SUBJECT: NYSERDA Comments on the Department of Energy (DOE) Responses to Requests for Additional Information (RAI) (Reference 1) for the *Phase 1 Decommissioning Plan (DP) for the West Valley Demonstration Project* from the Nuclear Regulatory Commission (NRC) (References 2, 3 and 4)

NYSERDA Comments on the Department of Energy Responses to Requests for Additional Information for the Phase 1 Decommissioning Plan (DP) for the West Valley Demonstration Project from the Nuclear Regulatory Commission

**Review of the
U.S. Department of Energy Responses to the
U.S. Nuclear Regulatory Commission
Requests for Additional Information on the West
Valley Demonstration Project Phase 1
Decommissioning Plan**

Figure 1. Schematic for Exposure Scenarios Initiated by a Sub-Surface Source

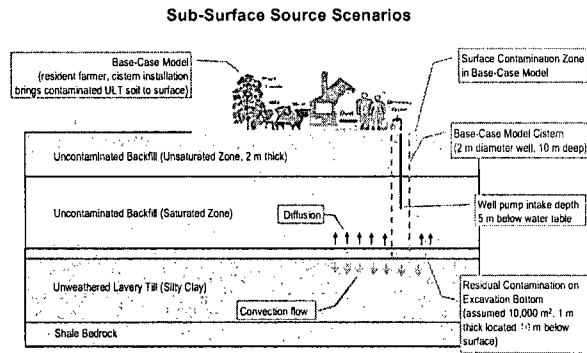
It is the understanding of this reviewer, based on the above, that DOE's response to RAI 5C6 relies on groundwater modeling which considers potential release of radionuclides from the bottom of a remediated excavation by diffusion. As noted in the second paragraph of my original comments on DOE Group 2 responses below, I consider such modeling inadequate. Instead, I expect contaminants from the bottom of each excavation to be drawn toward a pumping well completed within the backfill of the excavation not by a slow process of diffusion but much more rapidly by advection. Ignoring advection would underestimate the rate at which contaminants from the bottom of an excavation reach the well, thereby overestimating dilution and the derived DCGLs.

That such advection is disregarded is made clear by the recently submitted West Valley EIS/DPlan Calculation Package, Estimates of Human Health Impacts Due to a Sub-surface Source in the Vicinity of the Excavation at WMA1. As illustrated without ambiguity in Figure 1 of this package (reproduced below), (a) contaminants are taken to be released from the bottom of the excavation into the saturated zone of the backfill purely by diffusion, and (b) advective flow in Unweathered Lavery Till beneath the backfill is taken to continue being directed downward. In reality, a well pumping water from the saturated part of the backfill (pictured in Figure 1)

would cause groundwater flow, and hence advective transport, in the underlying shallow ULT to reverse course upward, through the contaminated bottom of the excavation (yellow in Figure 1), into the overlying (originally) uncontaminated saturated backfill, followed by lateral flow and contaminant advection toward the well.

The conceptual framework underlying the DOE revised calculations of contaminant transport from the contaminated bottom of a remediated excavation, through the originally uncontaminated saturated backfill, toward a well pumping water from the latter is fundamentally flawed and not conservative.
